Product Change Notification / SYST-11MXDX470

ERRATA - ATtiny4/5/9/10 Silicon Errata and Data Sheet Clarifications

ATtiny4/5/9/10

Silicon Errata and Data Sheet Clarifications

Figure 1-3. Serial Programming Timing

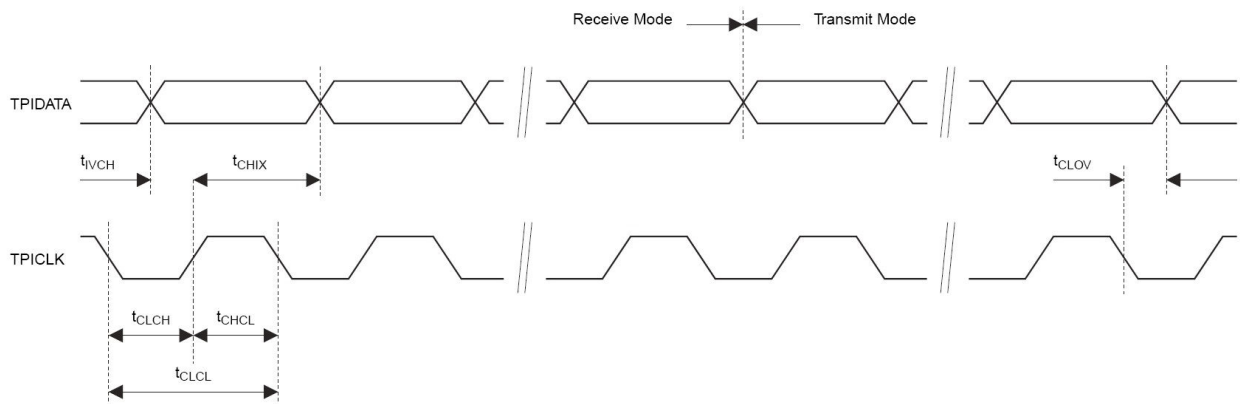
3.2.1 Serial Programming Characteristics

A clarification for the maximum temperature for serial programming, in *Appendix A - ATtiny4/5/9/10 Specification at 125°C* (ww1.microchip.com/downloads/en/DeviceDoc/8127_125.pdf), has been made.

The maximum temperature for serial programming is lowered.
